P.O.A.D.P. PLAN for EISENHAUER / FRATT 19

Re: Eisenhauer – Fratt 19 Subdivision POADP # 640

The City Staff Development Review Committee has reviewed Eisenhauer – Fratt 19 Subdivision Preliminary Overall Area Development Plan # 640. Please find enclosed a signed copy for your files. Although your plan was accepted, please note the following:

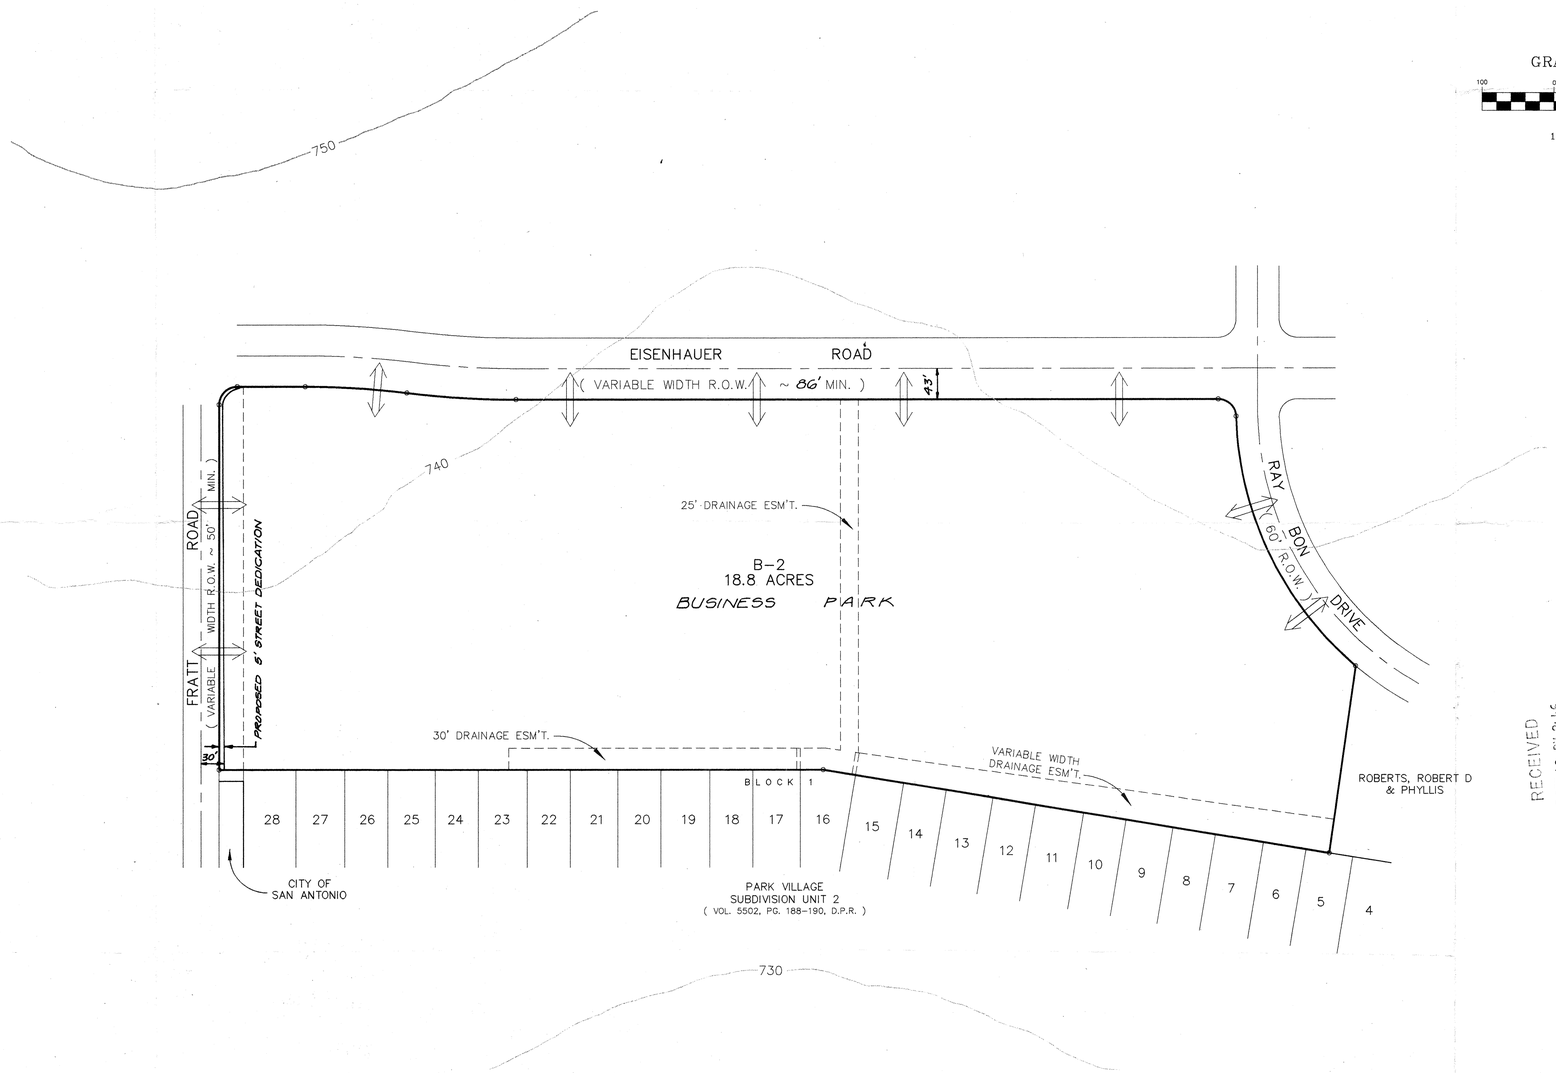
- Based on the topography, a Flood Plain Study and drainage review will probably be required during the platting process.
- According to the Major Thoroughfare Plan the Right of Way requirements for Fratt Road is 60', and Eisenhauer Road requires a minimum of 86'.

- In consideration of public safety and convenience, excessive grades by reason of topography should be avoided in street layouts and arrangements.
- Access along Eisenhauer Road, Ray Bon Drive and Fratt Road will be limited to two driveways each, with the understanding that the development would include shared access and internal circulation. Please note that fewer driveways on Ray Bon and on Fratt Road may be required at the time of Platting.

- It will be expected that you will plat all of the property depicted in your POADP, to include: floodpains, drainage areas and open space.
- I would encourage you to work closely with the school district, so that they can plan accordingly.

Comments: Drainage Easements will be required and will be address during the platting process

Comments: Drainage easements ~~on~~ will be required and will be address during the platting process.

Proposed to consist of various commercial lots, this property is estimated to generate up to 974 peak hour trips for a shopping center based on the 6th edition of the ITE Trip Generation Manual. With the intent of shared driveways and common access, these trips will be distributed through two access points on Eisenhauer, two located on Ray Bon Drive, and two located on Fratt Road.

Fewer driveways on Ray Bon and on Fratt Road may be required.
